**City Council
Agenda Memo**

SUBJECT: Appeal of a denial of a sidewalk waiver for Mad Coffee, located at 8049 Hwy 83-84.

RE: Sidewalks on Project Mad Coffee at US83-84 & FM 707

Re: Sidewalk Waiver Request for Mad Coffee, located at 8049 Hwy 83-84

Project Name and Address
Mad Coffee Site Plan

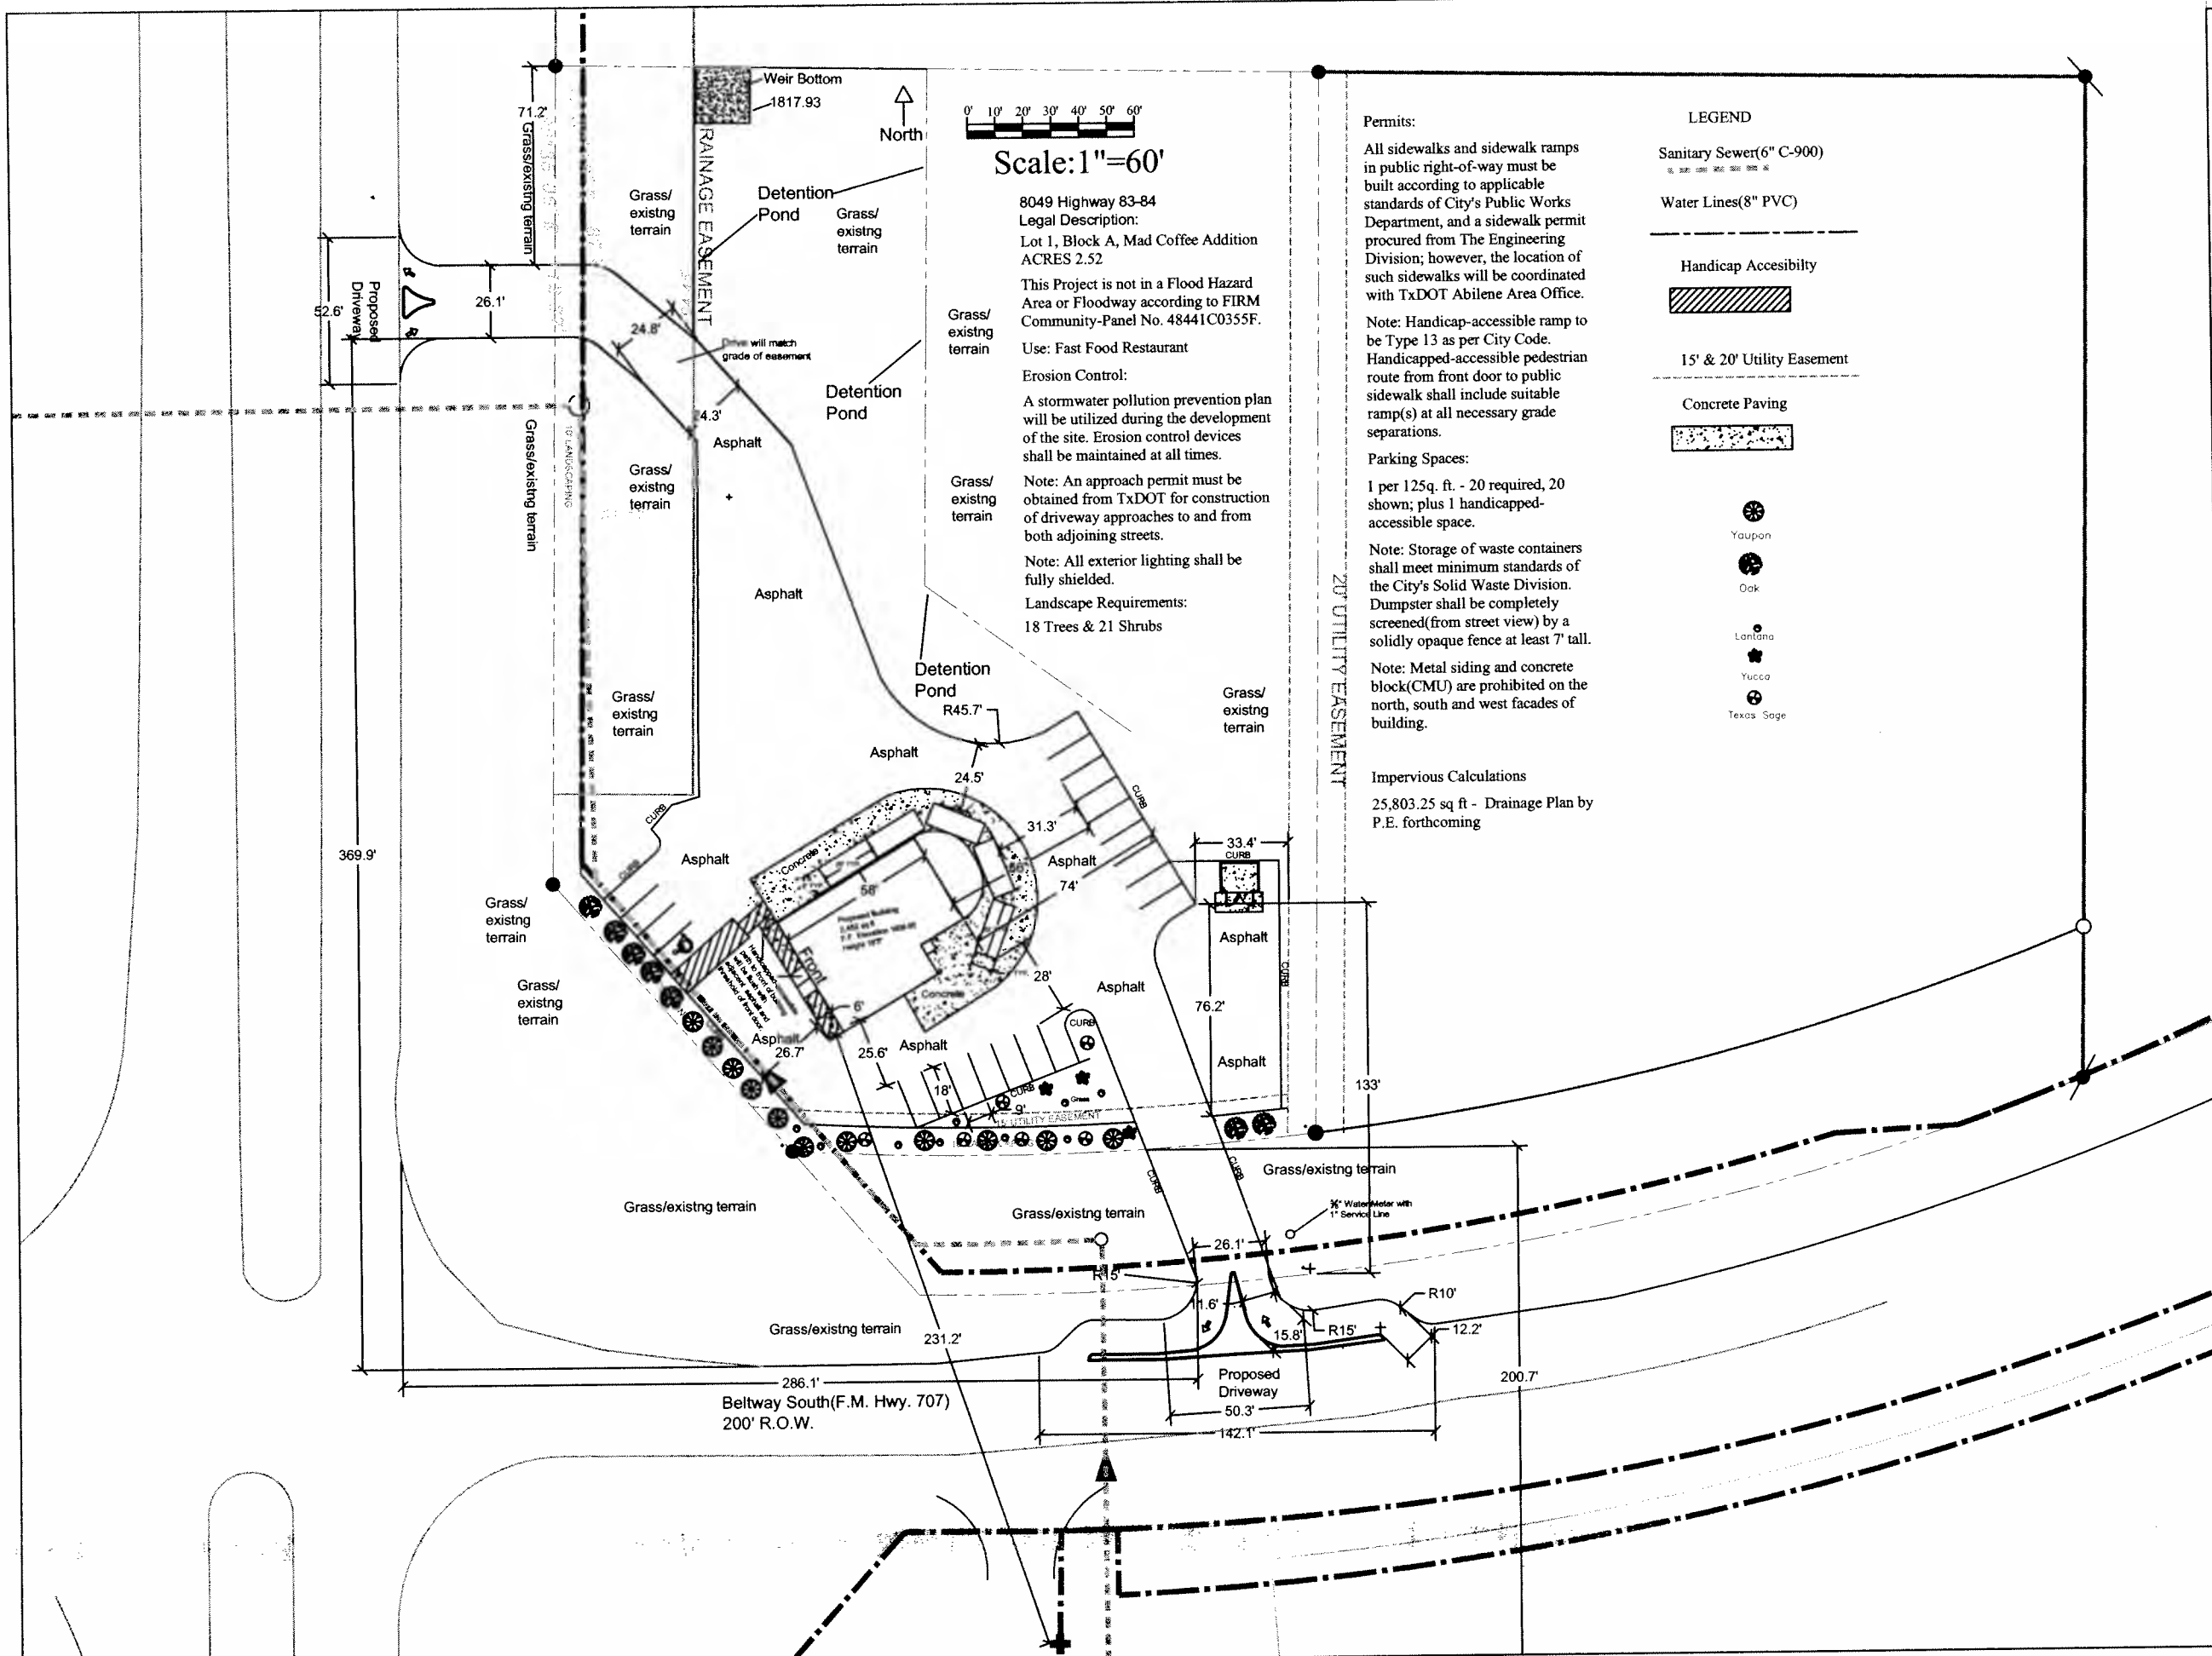
Regarding Beltway S., a sidewalk would create and begin an important sidewalk connection leading in both directions. A portion of the sidewalk currently exists within the TxDOT right-of-way, to which the sidewalk on this site would connect. It appears that adequate space exists for proper installation of a sidewalk, even with the noted topography issues.

Regarding Hwy 83-84, it would be similar to Beltway S. The City Engineer met with the TxDOT Area Engineer on the site to review the situation on the ground and both agreed that a sidewalk on the site is buildable and can be constructed in the TxDOT right-of-way or drainage easement with a minimal amount of grading work.

We are **denying** your request for a sidewalk waiver. The City's ordinance recognizes that major streets, like Beltway S. & the frontage road for Hwy 83-84, provide connectivity for a larger area and thus are expected to provide sidewalks. The intersection of these two roads is part of a Gateway/Mixed Use area identified on the City's Future Land Use Plan. The intersection will be a major retail/commercial node in the future and will generate pedestrian traffic.

Regarding Beltway S., a sidewalk would create and begin an important sidewalk connection leading in both directions. A portion of the sidewalk currently exists within the TxDOT right-of-way, to which the sidewalk on your site would connect. It appears that adequate space exists for proper installation of a sidewalk, even with the noted topography issues.

Regarding Hwy 83-84, it would be similar to Beltway S. The City Engineer met with the TxDOT Area Engineer on the site to review the situation on the ground and both agreed that a sidewalk on the site is buildable and can be constructed in the TxDOT right-of-way or drainage easement with a minimal amount of grading work.
